PG&E Letter DCL-15-142

Response to NRC Letter dated November 5, 2015, "Request for Additional Information Related to the Environmental Review of the Diablo Canyon Power Plant, Units 1 and 2, License Renewal Application (CAC Nos. MF4019 and MF4020)"

Pacific Gas and Electric Company's Response to Nuclear Regulatory Commission's "Request for Additional Information Related to the Environmental Review of the Diablo Canyon Power Plant, Units 1 and 2, License Renewal Application," dated November 5, 2015

Figure AIR-7-21

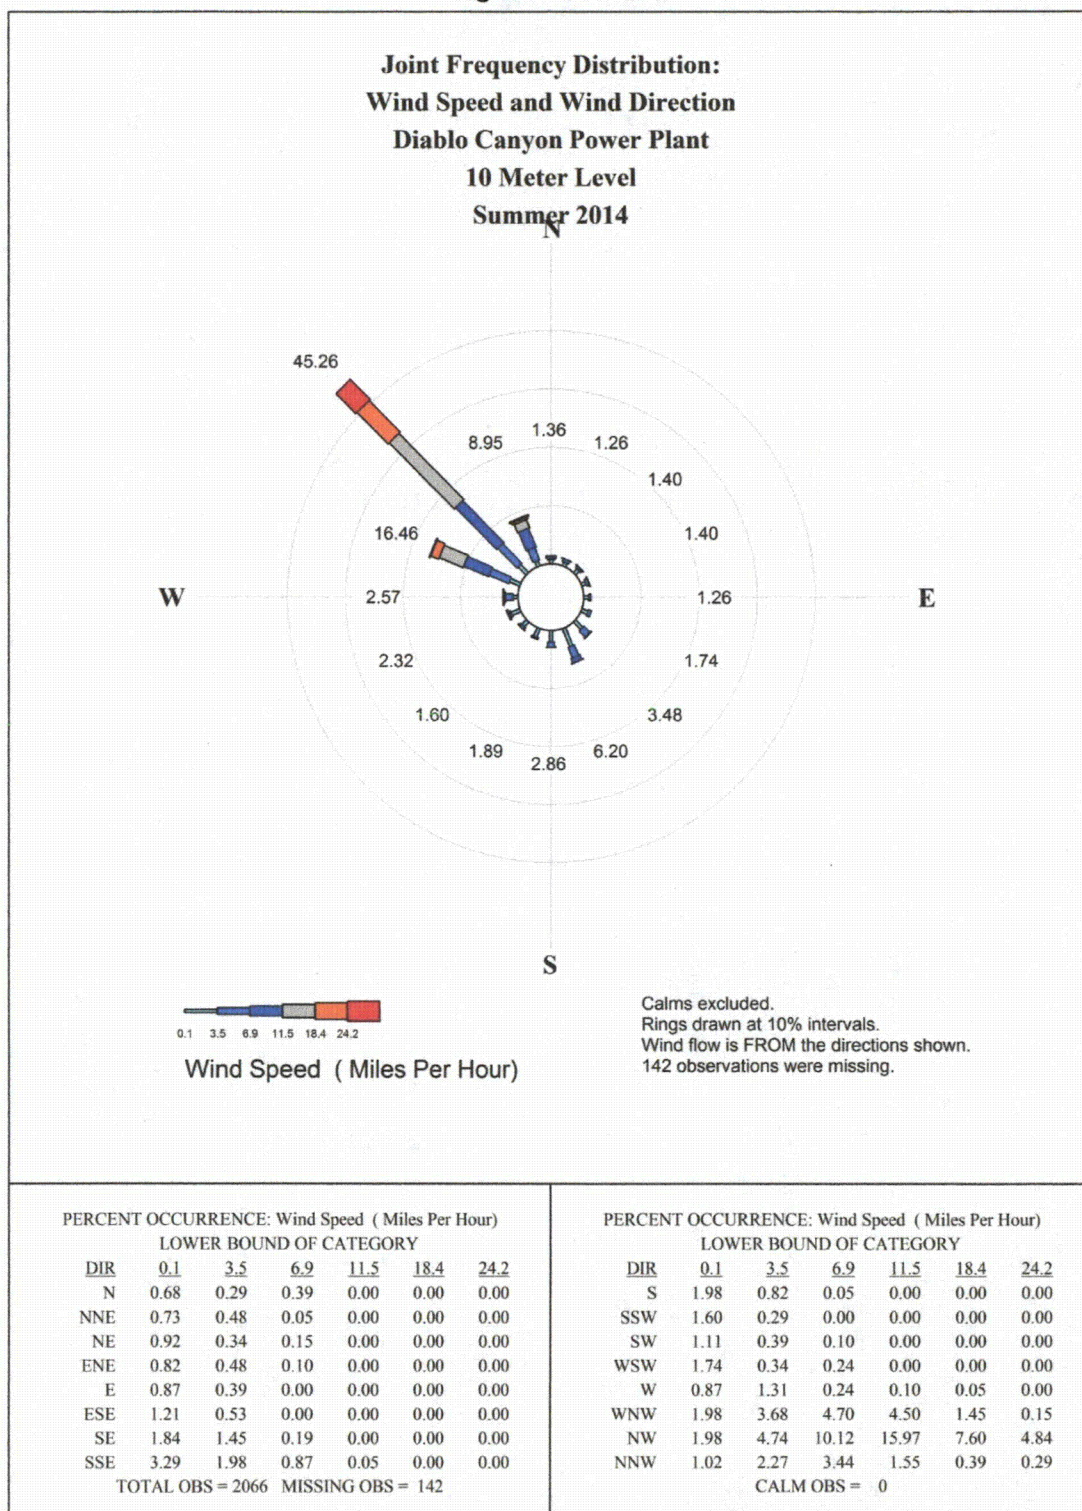
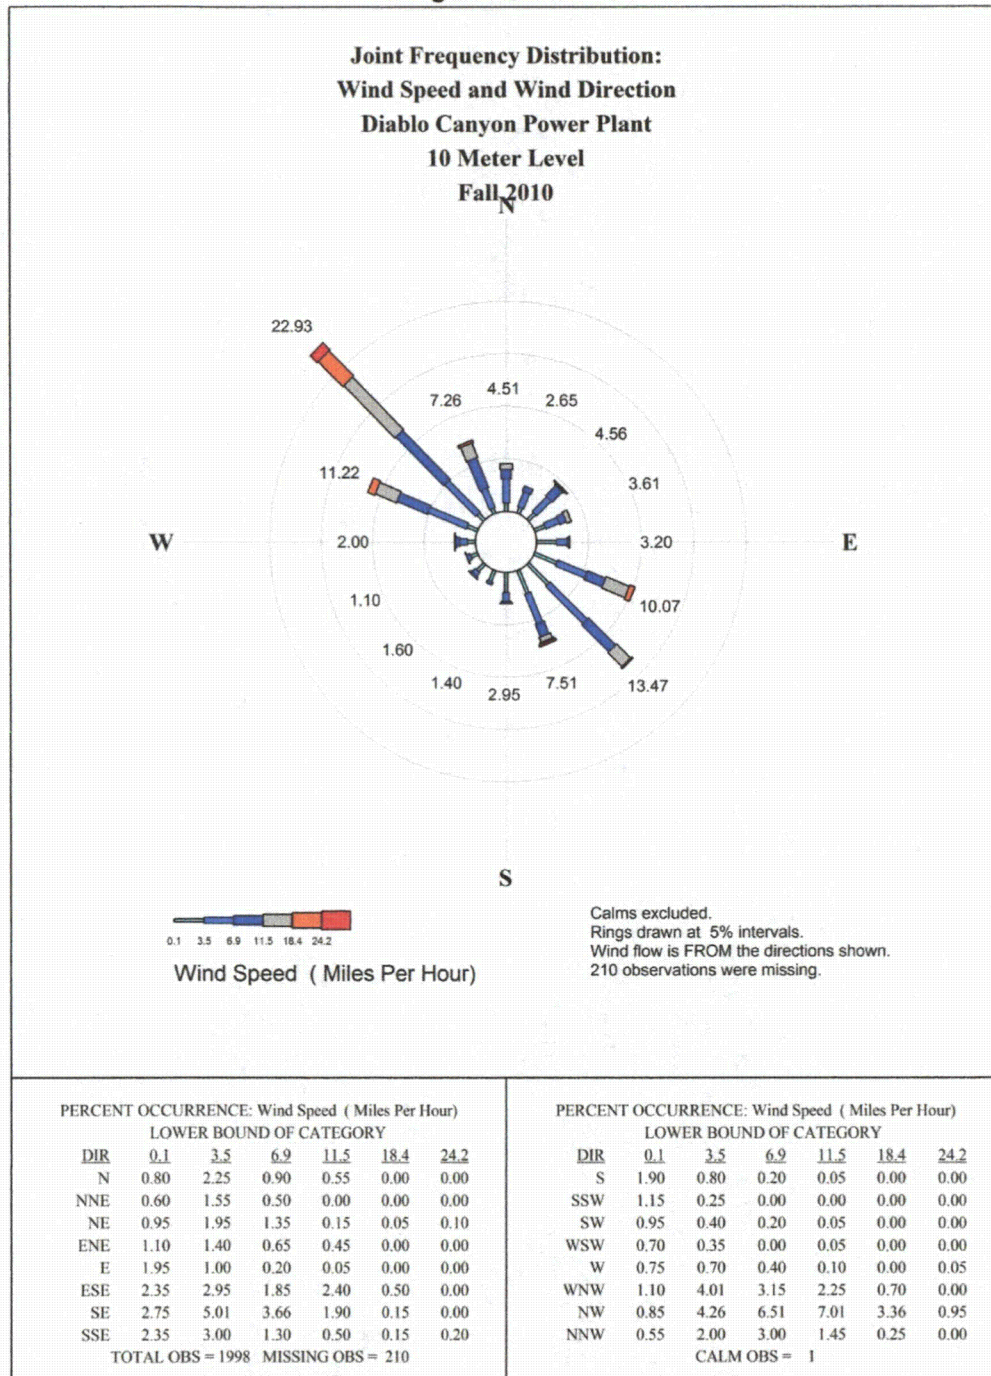
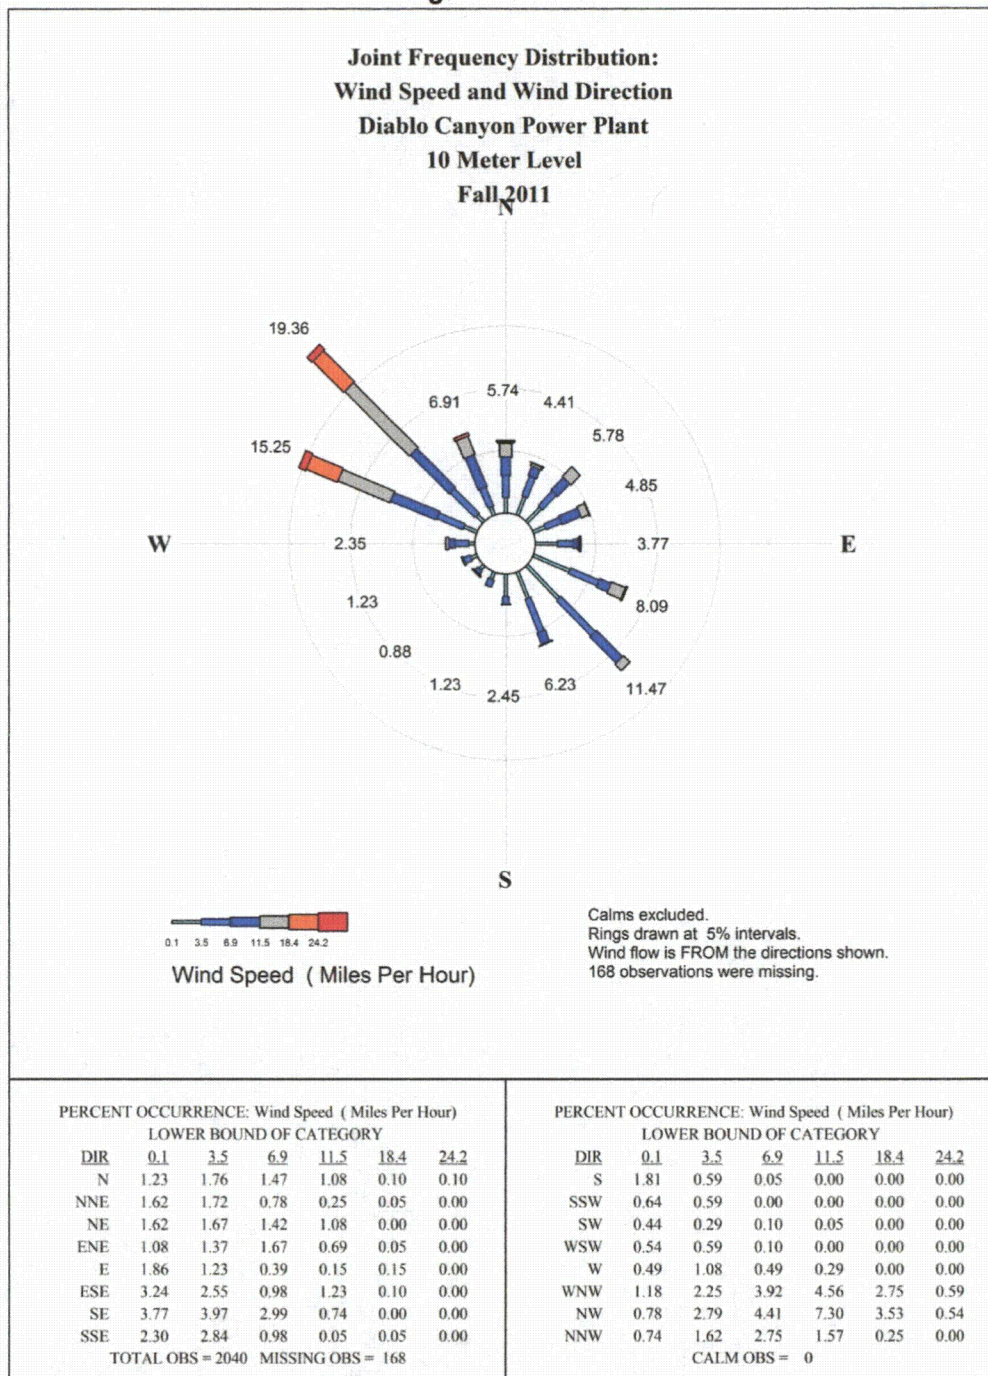
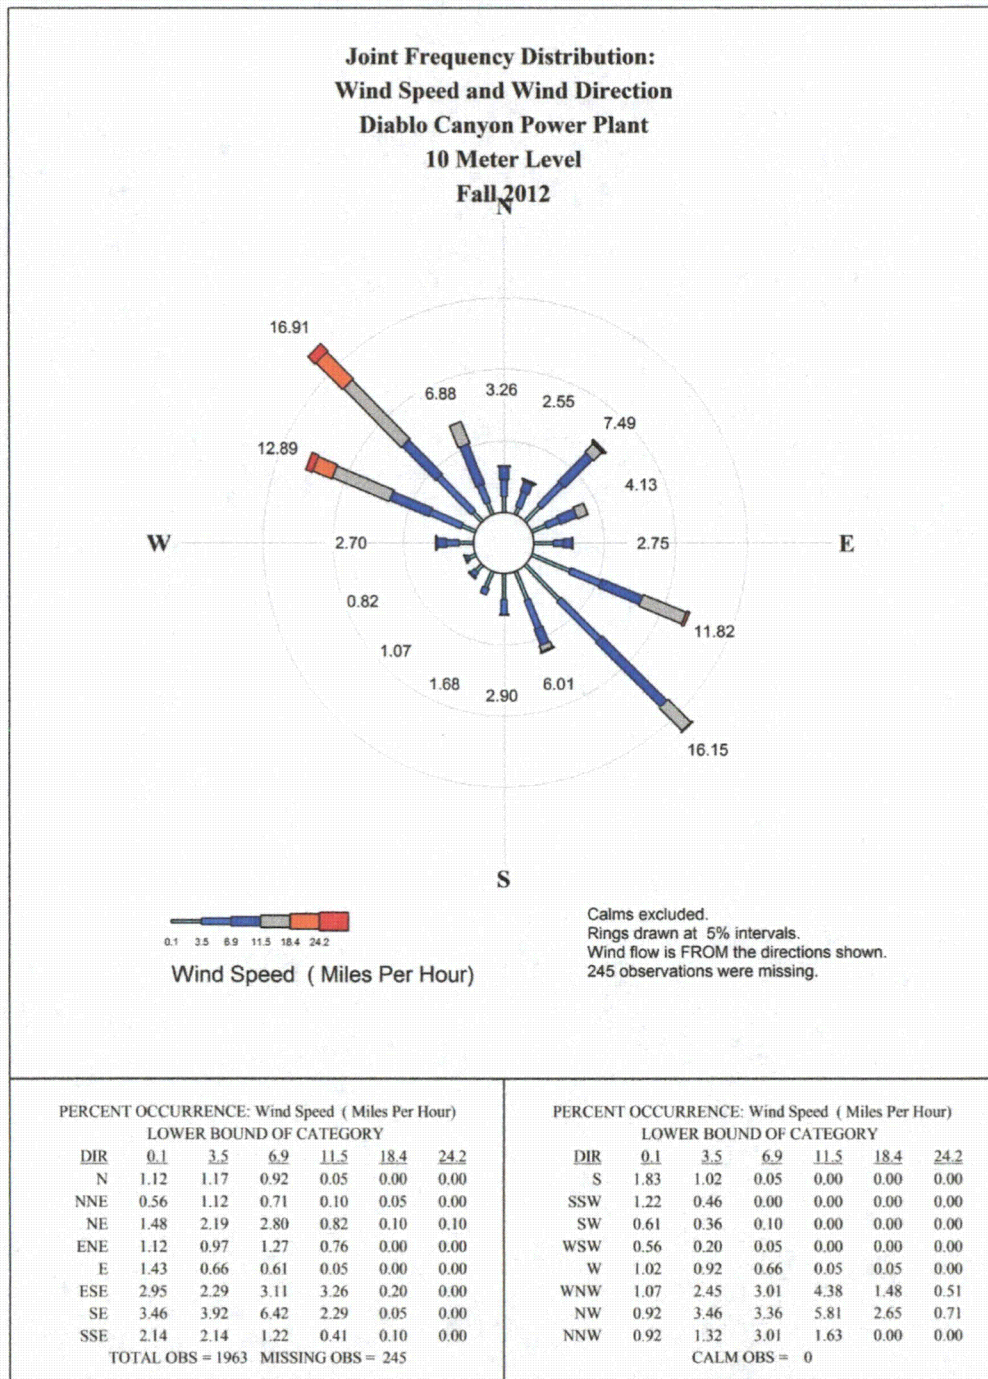
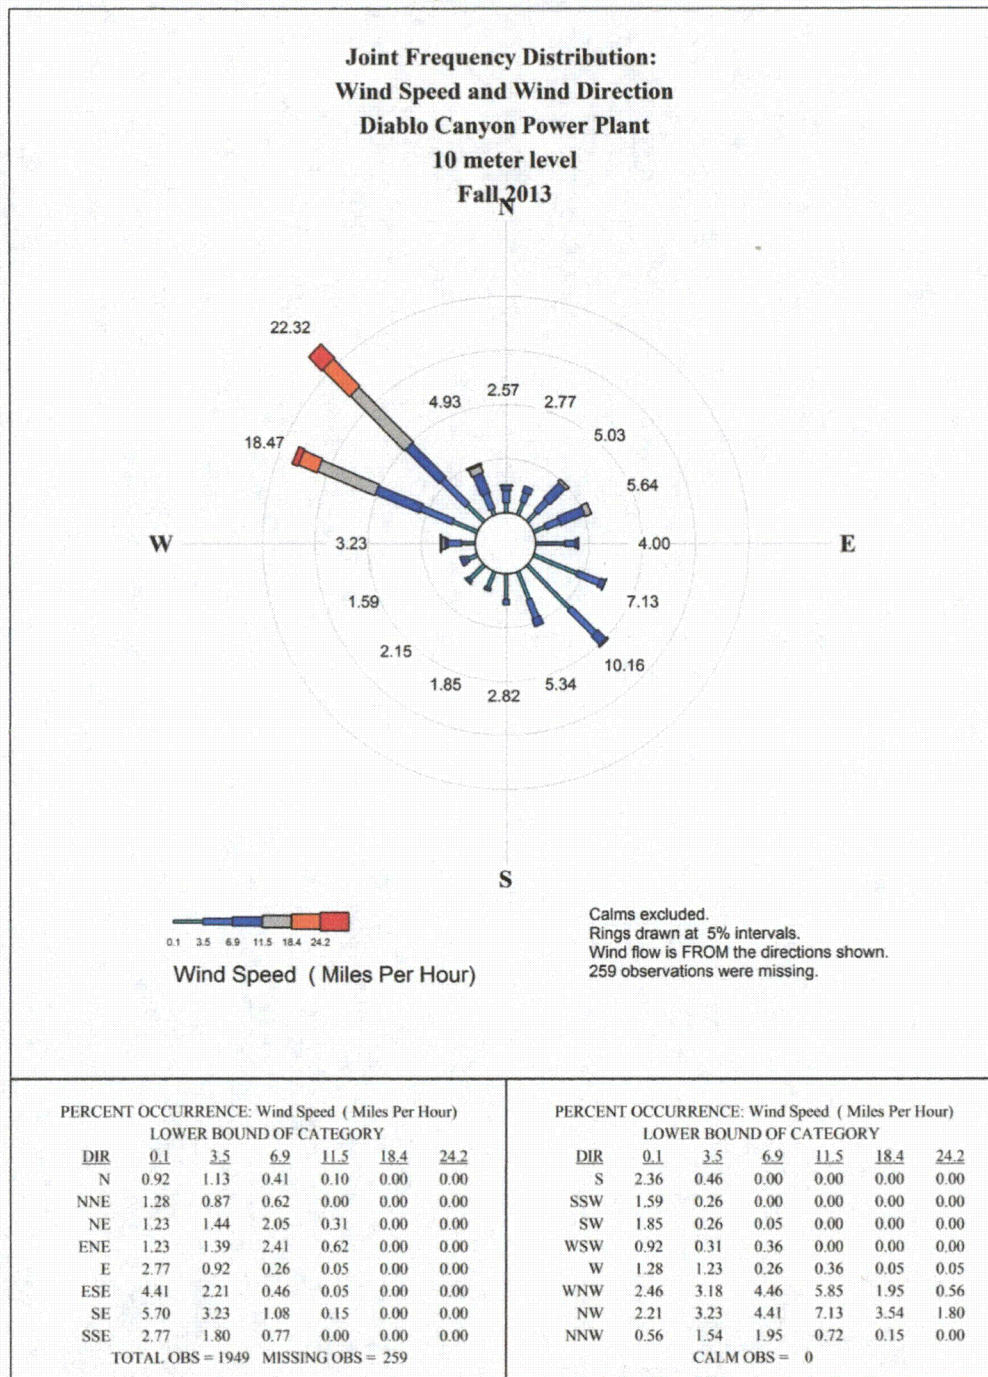
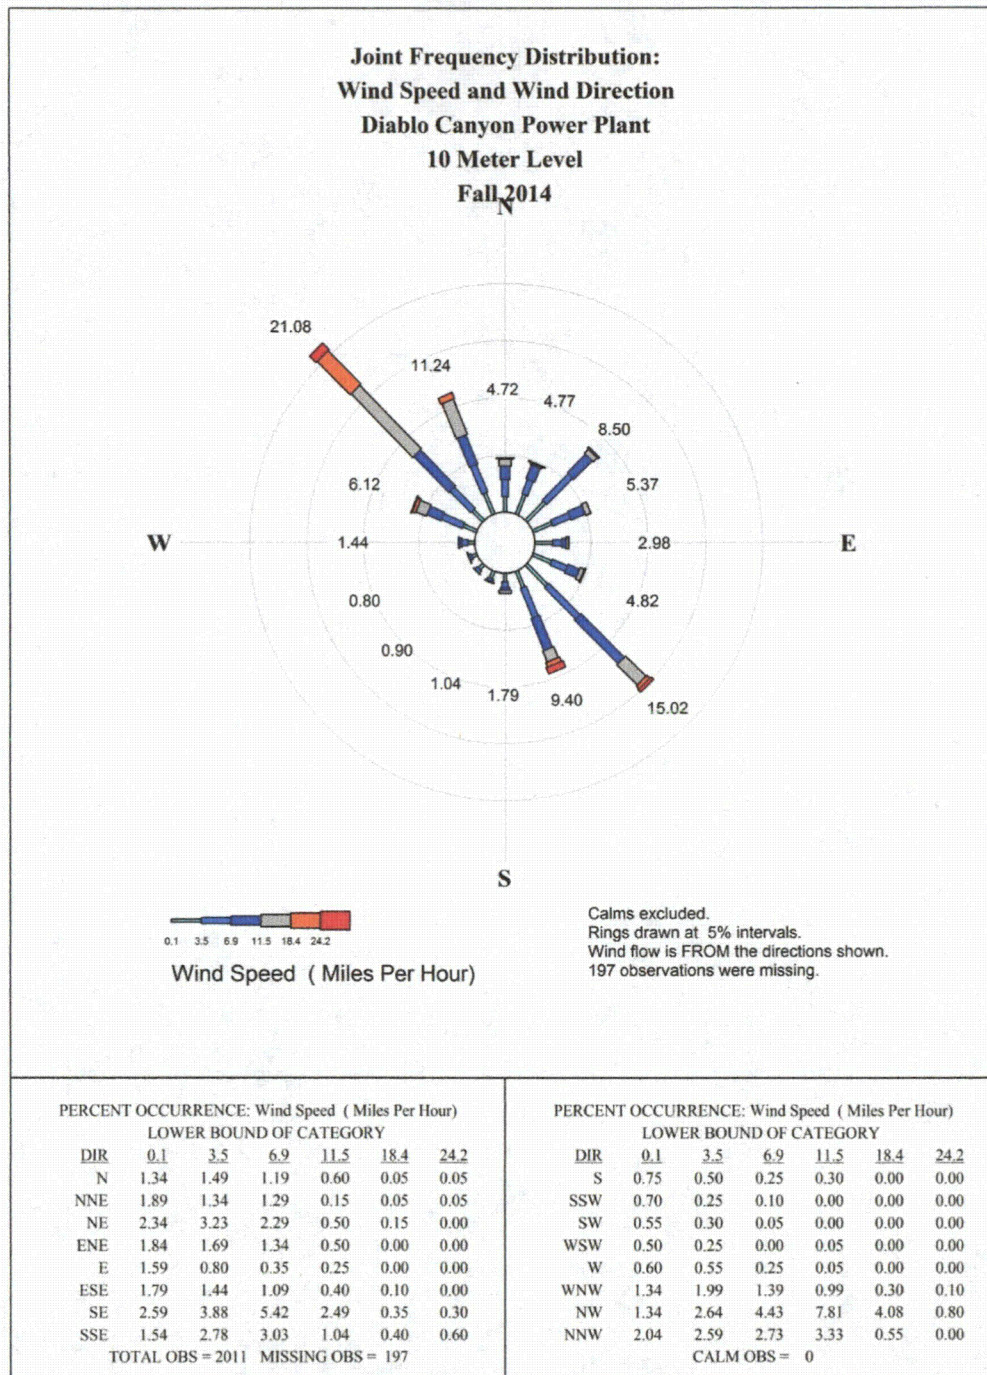
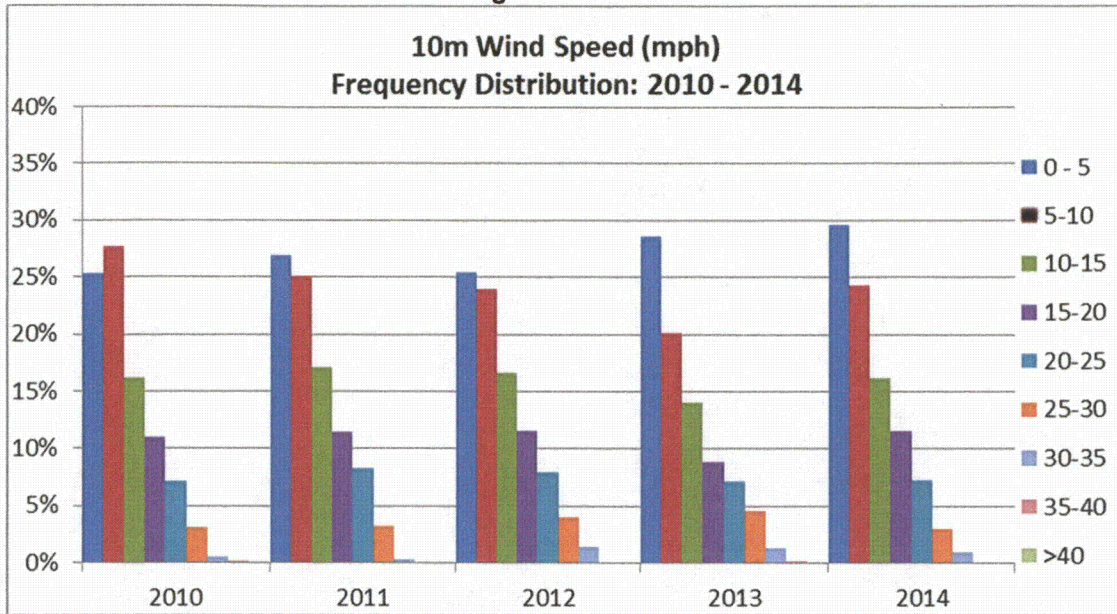
Provide seasonal and annual summary wind statistics in the form of wind direction and speed frequency distribution tables and wind roses from data recorded at DCP's meteorological facility. Discuss predominant wind direction and speed by season and annual average. The meteorological data should include the most recent 5 years for which the data are available.

The annual and seasonal wind direction frequency of occurrence for the DCP primary tower 10-m level for the period 2010 to 2014 are presented in Attachment 2, Tables AIR-7-1 through AIR-7-5. Annual and seasonal wind roses for DCP for the 2010 to 2014 periods are presented in Attachment 1 Figures AIR-7-1 through AIR-7-25. The wind rose presents the joint frequency of wind speed and wind direction recorded at the 10-m level at the plant. The wind direction is presented in 16 principal directions (north, north-northeast, northeast, north northwest) with each direction category encompassing a 22.5-degree sector centered on that direction. Six wind speed categories are used with the lower bounds at 0.1, 3.5, 6.9, 11.5, 18.4, and 24.2 miles per hour (mph). The length of each color band represents the frequency of a specific wind speed range. For example, northwesterly winds greater than 24.2 mph occurred 4.1 percent of the time for the period 2010 to 2014. Furthermore, below each wind rose diagram, is the same data displayed in table form for a more detailed breakdown of the seasonal wind direction and speed frequency distribution.
